SUBJECT: Forwards rev to 940314 response to NRC 931025 RAI re Topical
Rept WPPSS-FTS-131, "Applications Topical Rept for BWR
Design & Analysis."

Subject: **NUCLEAR PLANT NO. 2, OPERATING LICENSE NPF-21
REVISED RESPONSE TO REQUEST FOR ADDITIONAL INFORMATION
REGARDING TOPICAL REPORT WPPSS-FTS-131, "APPLICATIONS
TOPICAL REPORT FOR BWR DESIGN AND ANALYSIS" (TAC NOS.
M77048 AND M81723)**

**REVISED RESPONSE TO REQUEST FOR ADDITIONAL INFORMATION REGARDING
TOPICAL REPORT WPPSS-FTS-131**

**REVISED RESPONSE TO
REQUEST FOR ADDITIONAL INFORMATION
WASHINGTON PUBLIC POWER SUPPLY SYSTEM
TO REVISION 1 OF TOPICAL REPORT WPPSS-FTS-131**

Figure 1-1 LRNB Results, Using SPC
Forcing Functions

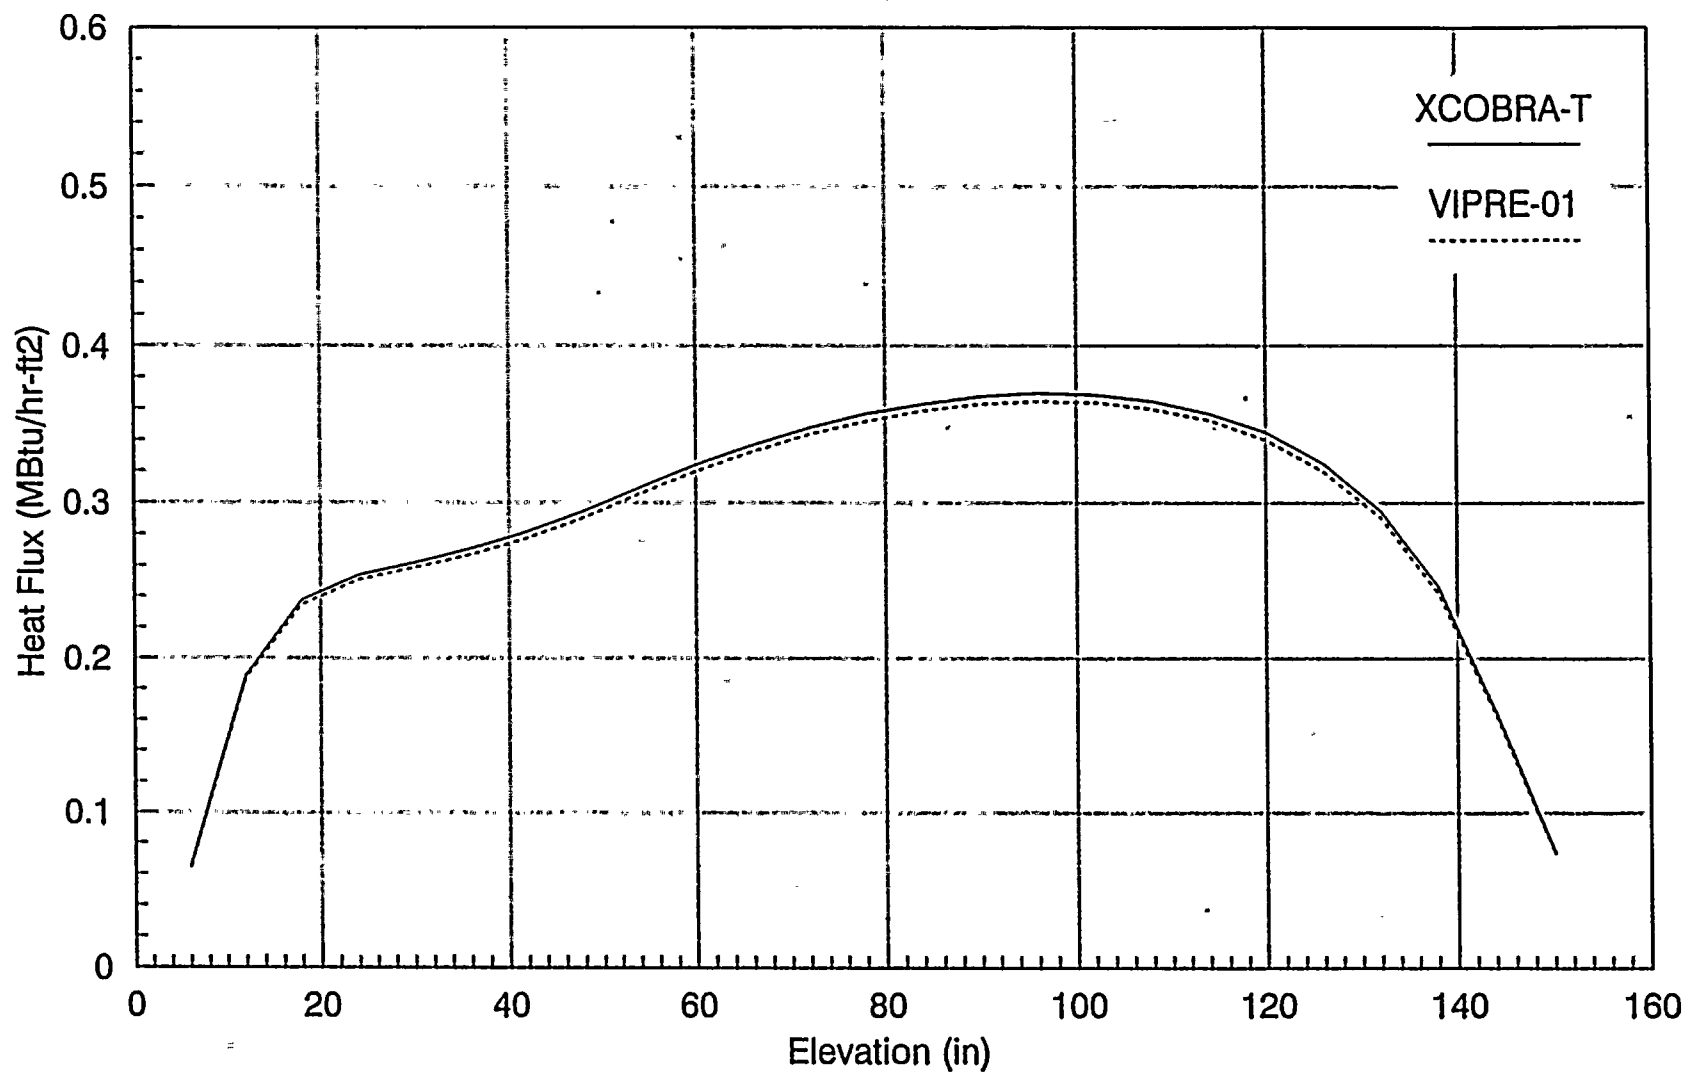
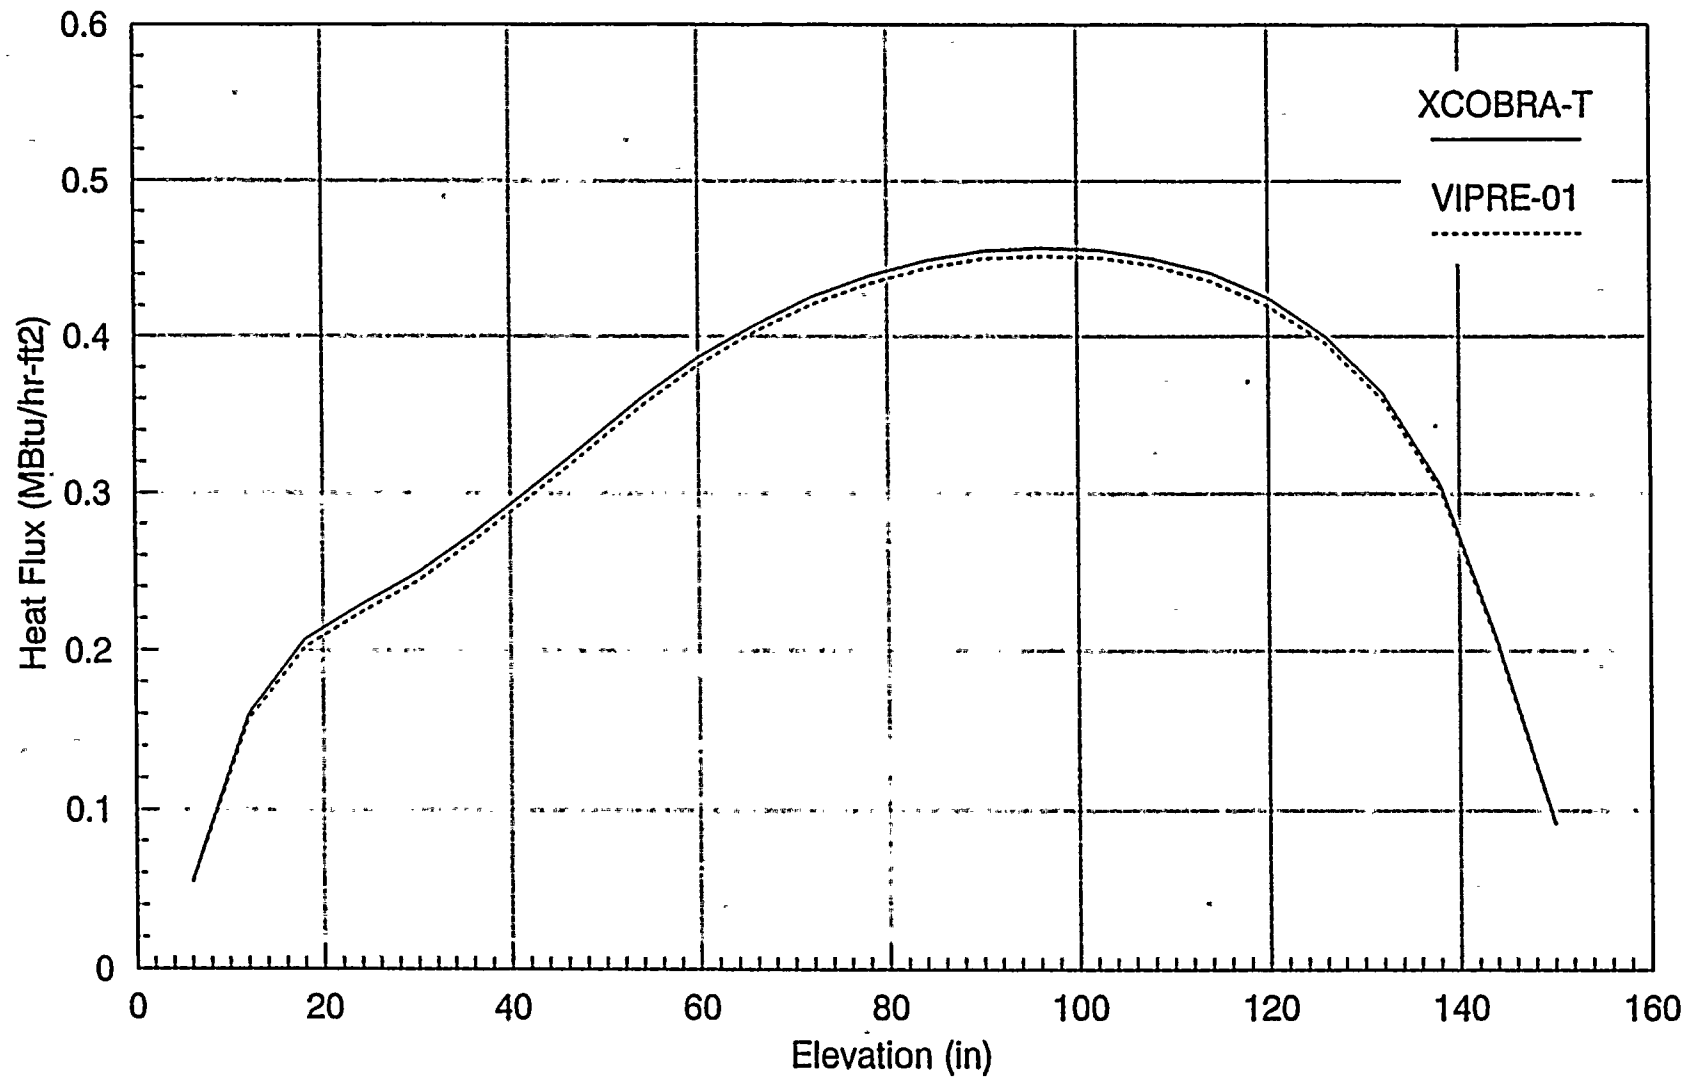
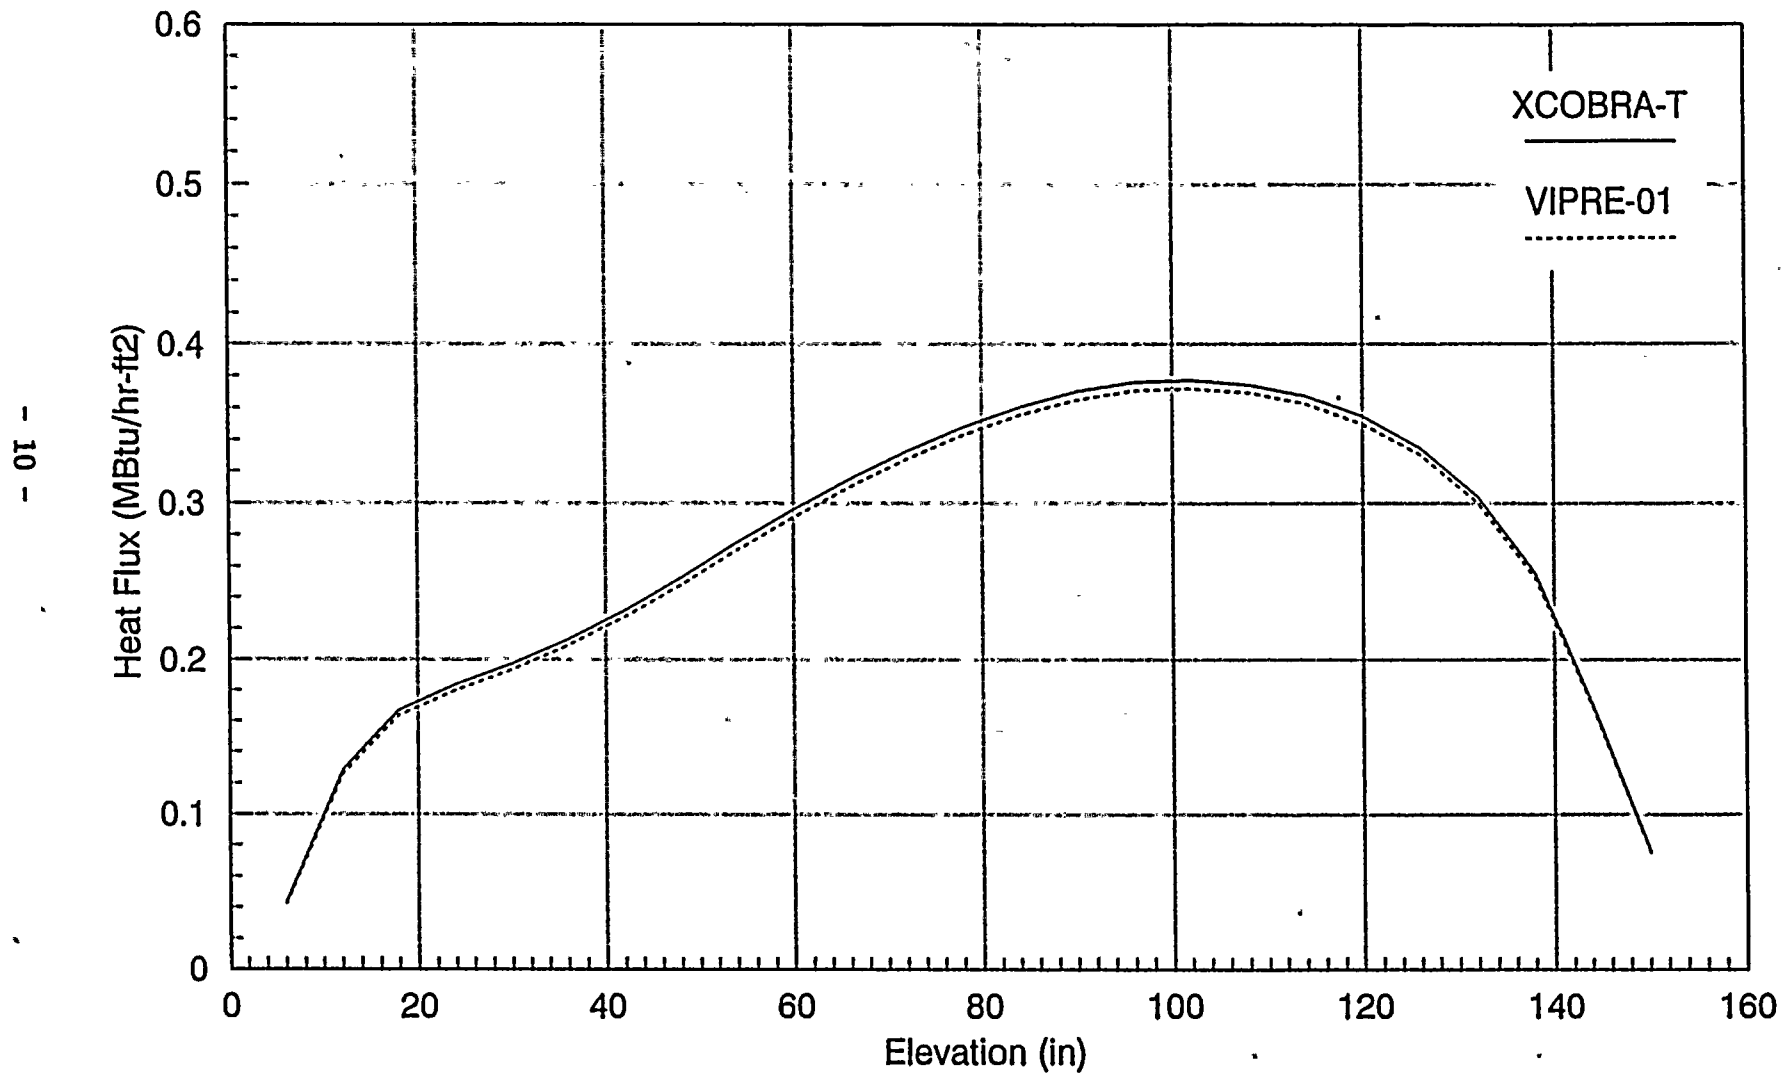
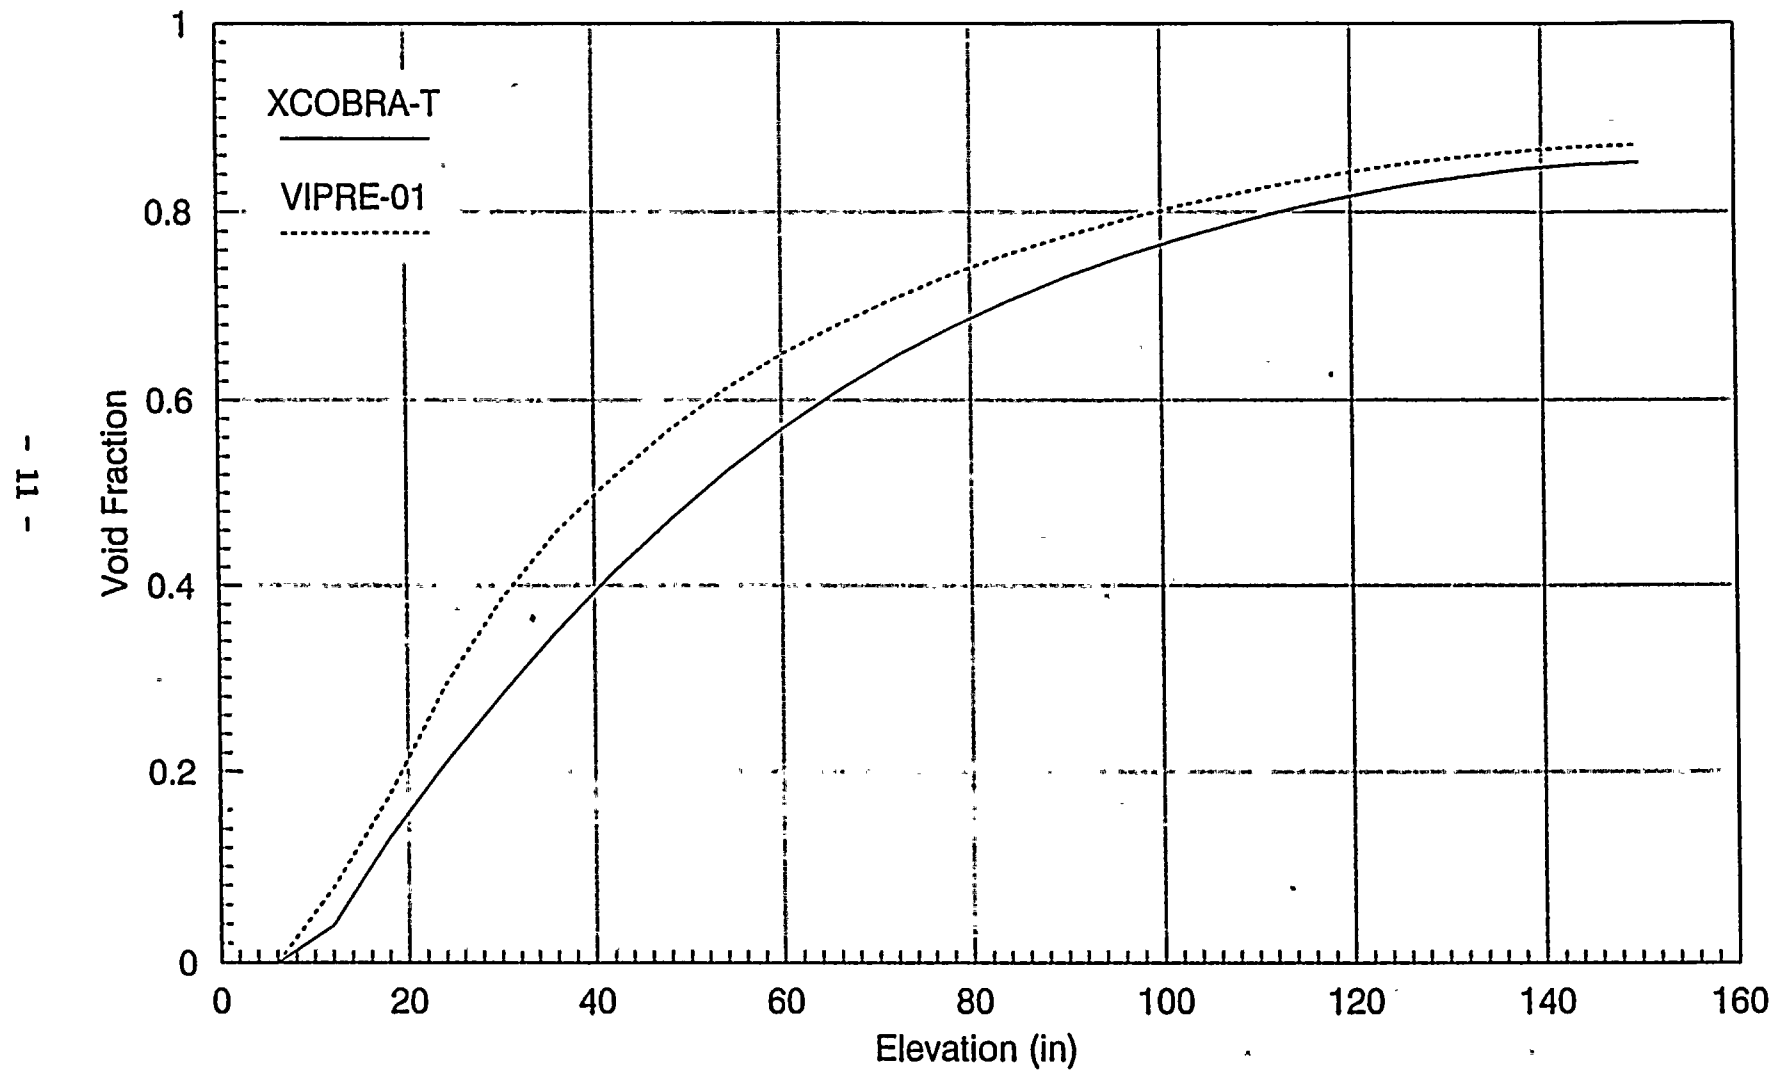
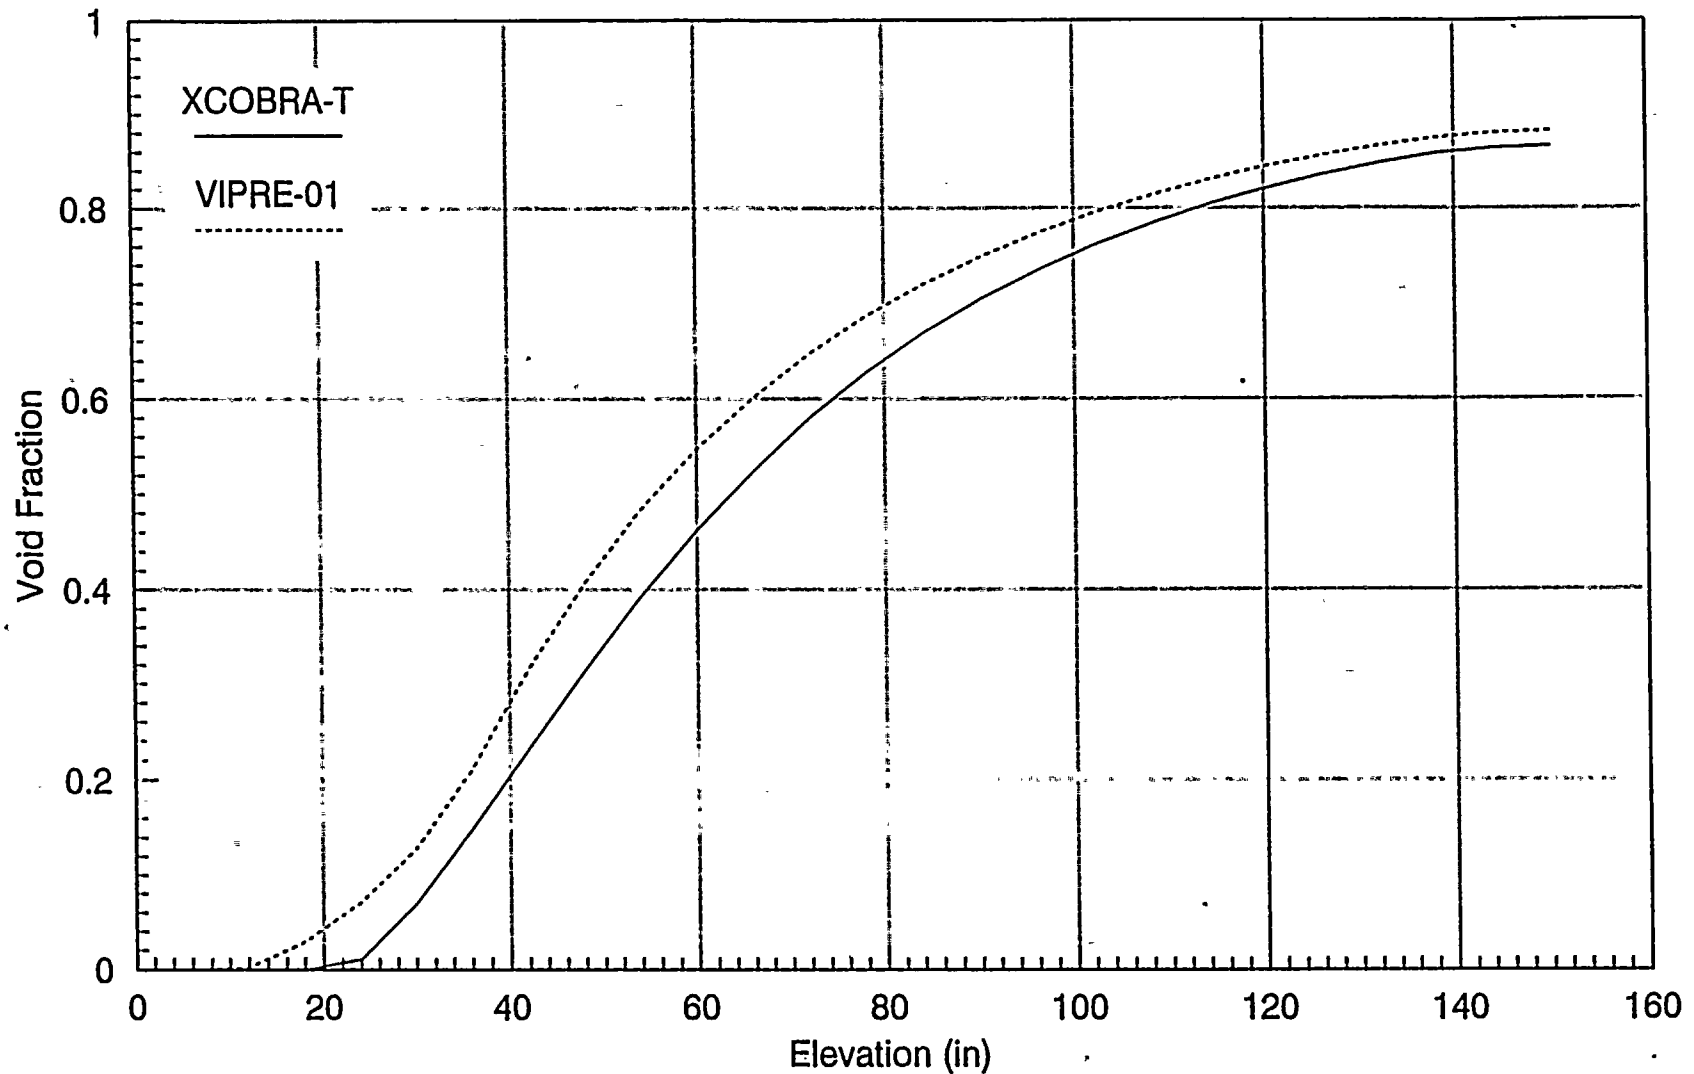
Question 1

For the most limiting transient, Load Rejection without Bypass, additional comparisons (axial void fraction at 0.0 s, 2.5 s and surface heat flux at 0.0 s, 1.2 s, 2.5 s) are shown in Figures 1-1 through 1-5. It is noted that the time of 1.2 seconds used in Figure 1-2 is when the critical heat flux ratio reaches its minimum. Even though the Drift Flux Model in VIPRE-01 predicted a higher void fraction (Figures 1-4 and 1-5), the combination of flow and heat transfer correlations resulted in a predicted surface heat flux that is in good agreement with that predicted by XCOBRA-T (Figures 1-1 through 1-3). Accurate prediction
